CITY OF OAKLAND

Memorandum

Subject: Proposal at 2008 Wake Avenue – Continued from December 11, 2019 Design Review Committee Meeting;

Location:	2008 Wake Avenue
Assessor's Parcel Number(s):	018 050800700
Proposal:	Construct a 171,765 sq.ft. 50-foot tall recycling facility on vacant parcel at the former Oakland Army Base. The building will serve as the new California Waste Solutions Recycling (CWS) facility.
Applicant:	RPR Architects
Contact Person/ Phone Number:	Kathleen Rousseau representing California Waste Solutions (CWS) 510-272-0654
Owner:	City of Oakland
Case File Number:	PLN19158
Planning Permits Required:	Major Conditional Use Permit
General Plan:	Business Mix
Zoning:	Gateway District Industrial Zone (D-GI)
Environmental Determination:	TBD
Historic Status:	NA
City Council District:	District 3
Finality of Decision:	NA
For Further Information:	Contact Case Planner: Corey Alvin, (510)238-6316 or calvin@oaklandca.gov

EXHIBIT 3
Proposed CWS Facility Truck Routing

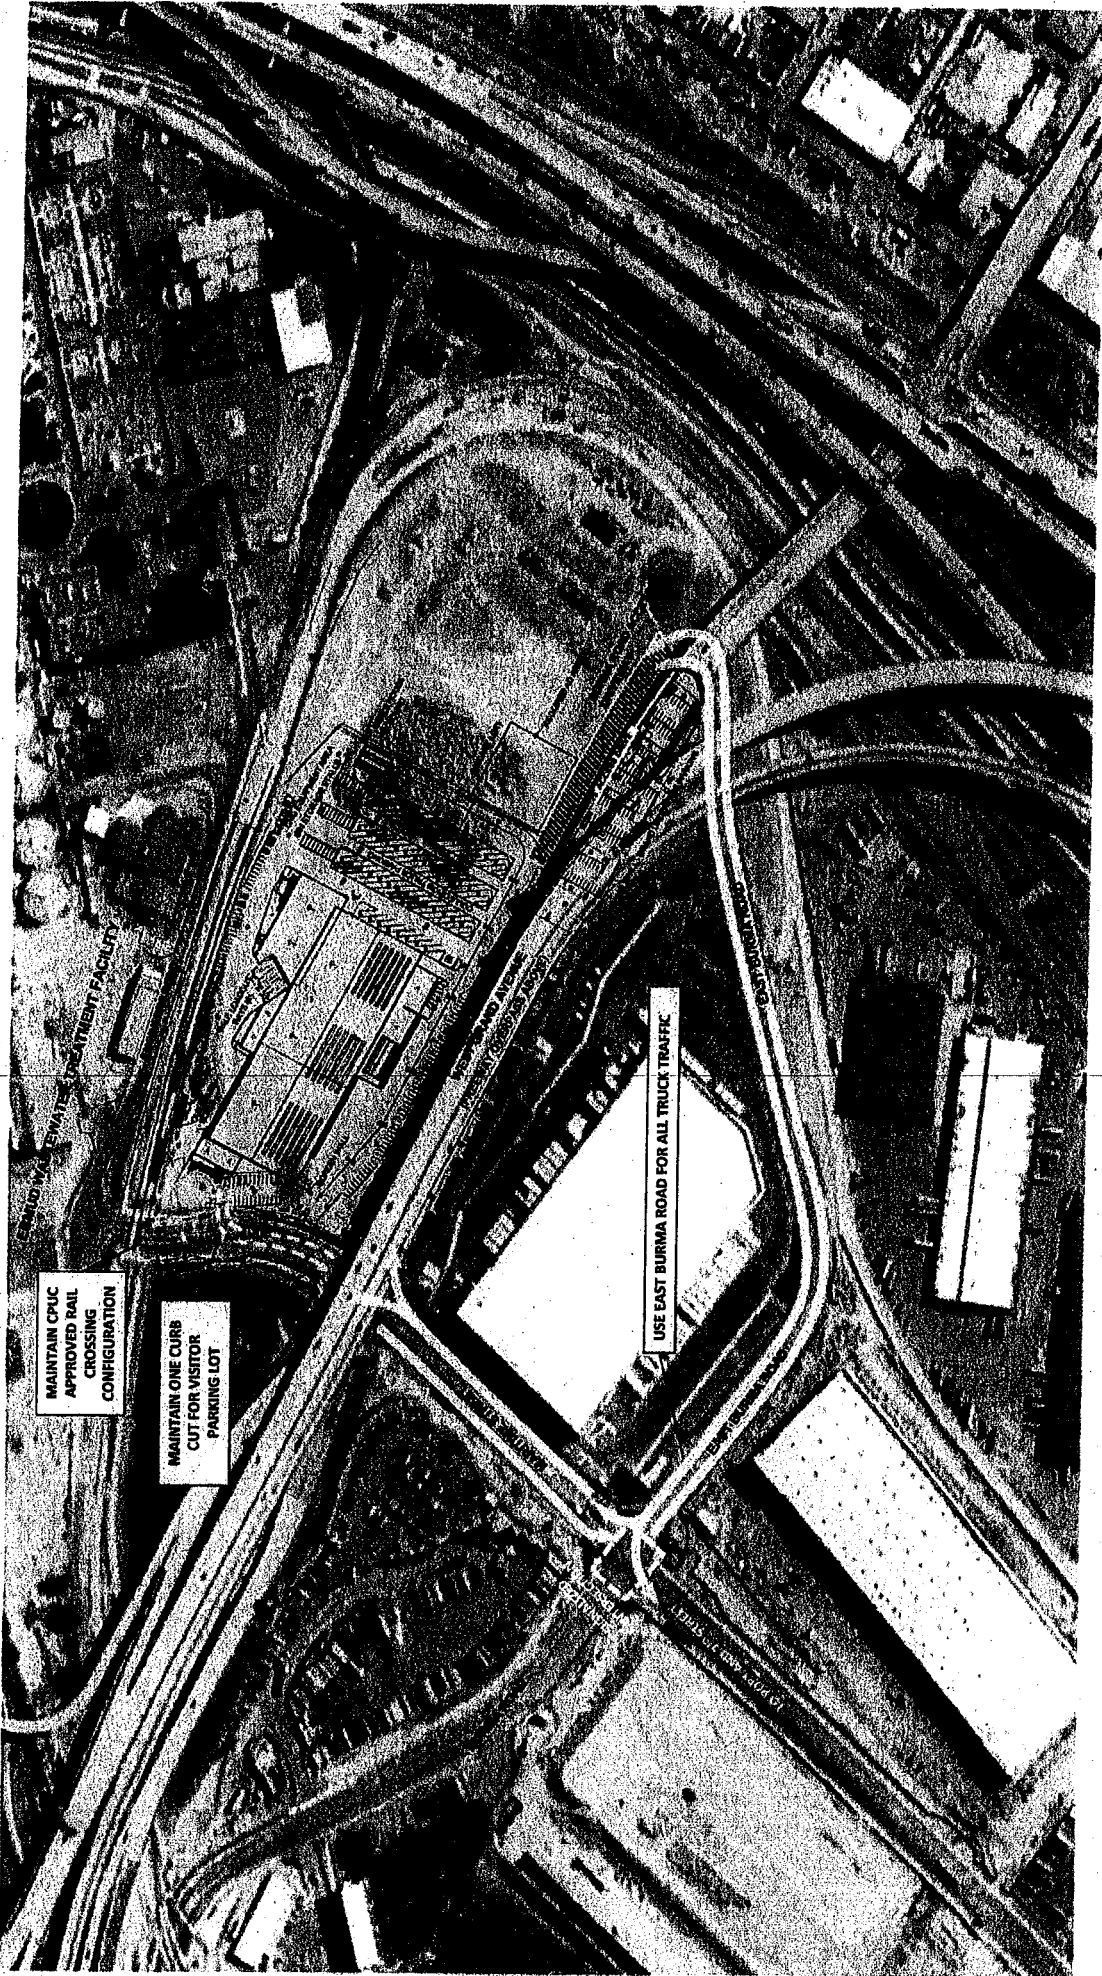
EBMUD believes that all of these concerns would be addressed if CWS uses the East Burma Road extension as the primary ingress and egress from the Facility (Exhibit 3). The new East Burma Road extension is identified in the 2012 Oakland Army Base Project Initial Study/Addendum as secondary emergency access from the relocated Wake Avenue through the properties in the North Gateway, and the CWS proposed site plan indicates connectivity through the "Burma Road Access Driveway." If that road were utilized as a primary ingress and egress, vehicles leaving the Facility would benefit from the four-way stoplight at Burma Road and Maritime Street and by making right turns back to West Grand Avenue. In addition, this would provide the most direct route for the large transfer trucks going to the Port. The Wake Avenue ingress/egress for the Facility could then be limited to accessing the visitor parking lot utilizing the existing curb cut already constructed for the property.

MAINTAIN CPUC
APPROVED RAIL
CROSSING
CONFIGURATION

MAINTAIN ONE CURB
CUT FOR VISITOR
PARKING LOT

USE EAST BURMA ROAD FOR ALL TRUCK TRAFFIC
